# Access Compliance Report

## Public Rights-of-Way

### (Curb Ramps)

Intersection ID: 4382	Main Street: NEWCHURCH_CR	Cross Street: SYMPHONY_WOODS_DR	Location:	N
ADA ID: 01A1FAE2F815	Ramp Type: Perp	Initial Pass/Fail: Fail	Overall Compliance: No	Severity Score: 58.75
Codes/Mitigation Info/Possible Solution		Field Measurements/Component Compliance

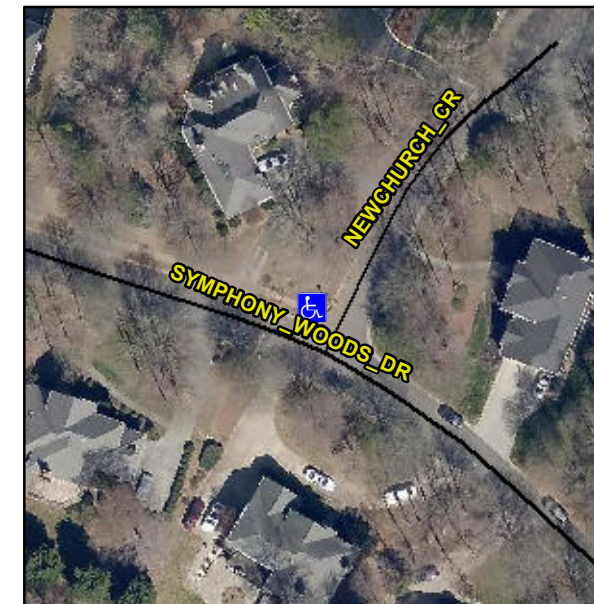
**Not Found, R304.5.1, R304.2.2, R304.5.3**

Compliance	Description	Data	Compliance	Description	Data
N/A	Ramp Length (in)	95.0	No	Ramp Slope (%)	12.6
No	Ramp Width (in)	46.5	No	Ramp XSlope (%)	9.1
N/A	Flare Type LT	N/A	N/A	Flare Type RT	N/A
N/A	Flare Slope LT (%)	N/A	N/A	Flare Slope RT (%)	N/A
N/A	Flare Traversable LT?	N/A	N/A	Flare Traversable RT?	N/A
N/A	Landing Length (in)	N/A	N/A	DWS Provided?	N/A
N/A	Landing Width (in)	N/A	N/A	DWS Contrast?	N/A
N/A	Landing Slope (%)	N/A	N/A	DWS Length (in)	N/A
N/A	Landing X Slope (%)	N/A	N/A	DWS Full Width?	N/A
N/A	Landing Curb? (Y/N)	N/A	N/A	DWS Offset (in)	N/A
N/A	Shared Landing?	N/A			
N/A	Gutter Ponding?	N/A	N/A	Gutter Slope (%)	N/A
N/A	Gutter Lip Ht (in)	N/A	N/A	Gutter X Slope (%)	N/A
N/A	Painted X Walk1?	No	N/A	Painted X Walk2?	N/A
	X Walk 1 Direction	To SW		X Walk 2 Direction	N/A
N/A	X Walk 1 Width (in)	N/A	N/A	X Walk 2 Width (in)	N/A
	X Walk 1 Slope (%)	3.0		X Walk 2 Slope (%)	N/A
	X Walk 1 X Slope (%)	5.3		X Walk 2 X Slope (%)	N/A

**Remove & Replace Entire Ramp.**
